FORM 129 – ADVISORY NEIGHBORHOOD COMMISSION (ANC) REPORT

| Case No.: | 20380 | Case Name: | Polygon Holdings, LLC |

Re: Case Number: 20380
Property Address: 4457 MacArthur Boulevard N.W.
Applicant: Polygon Holdings LLC

Re: Existing roof structure check

Figure 6 - Configuration of snow drift (Fig. 7-8, Ref. 2-1)

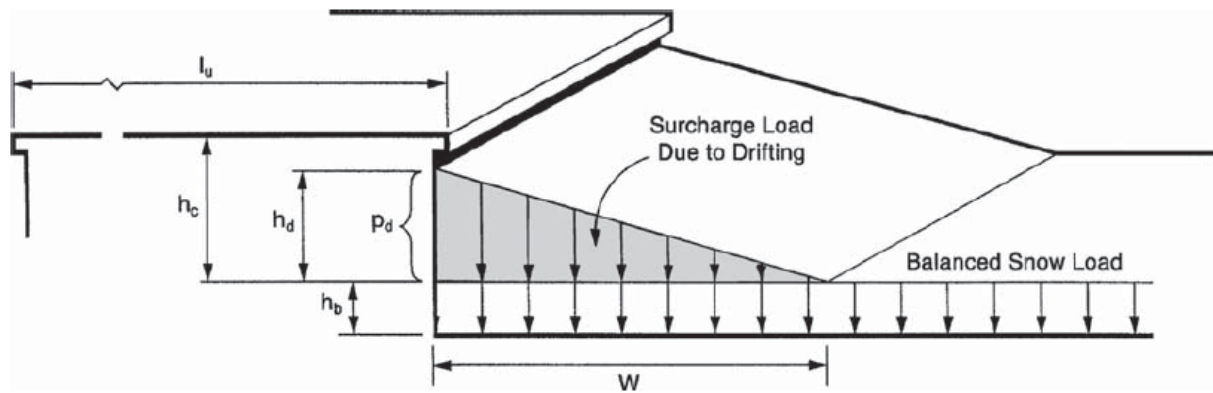
Calculate Snow Drifts near parapet:

Parapet Height per architecture: $h_{pr} := 42 \text{ in}$

Clear height : $h_c := h_{pr} - h_b = 2.209 \text{ ft}$

Calculate_drift := if $\frac{h_c}{h_b} < 0.2$ |
 || "No Drift"
 else |
 || "Yes" | Calculate_drift = "Yes" (7.7.1, Ref. 2-1)

Height of snow drift : $h_d := \frac{3}{4} \left(0.43 \cdot \sqrt[3]{\frac{l_u}{\text{ft}}} \cdot \sqrt[4]{\frac{p_g}{\text{psf}} + 10} - 1.5 \right) \text{ ft} = 1.649 \text{ ft}$ (Fig. 7-9, Ref. 2-1)

Figure 7 - Snow drift equivalent load

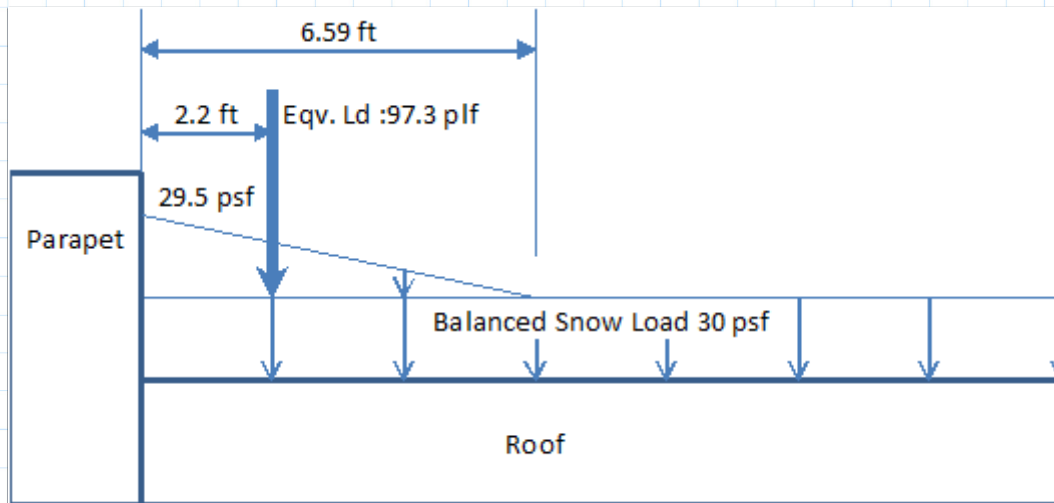
Equivalent Snow Drift : $SD_{eqv} = 97.316 \text{ plf}$

Distance of equivalent load to parapet : $SD_{dist} = 2.198 \text{ ft}$

DESCRIPTION: **Roof Joists check for Bending**

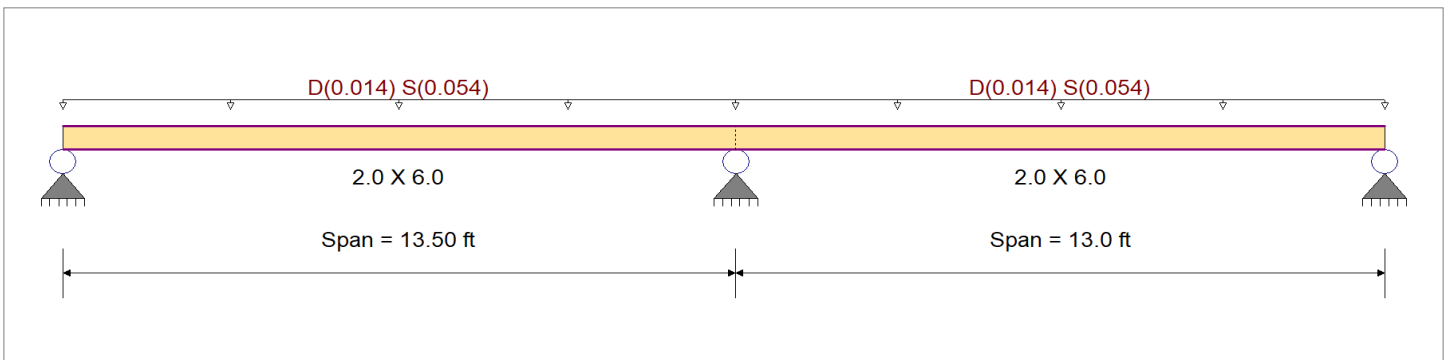
Load for Span Number 1
 Uniform Load : D = 0.0070, S = 0.0270 ksf, Tributary Width = 2.0 ft, (Snow Load)
 Load for Span Number 2
 Uniform Load : D = 0.0070, S = 0.0270 ksf, Tributary Width = 2.0 ft, (Snow Load)

No additional capacity for snow drift

| Maximum Bending Stress Ratio | = | 0.999 | 1 | Maximum Shear Stress Ratio | = | 0.404 | : 1 |
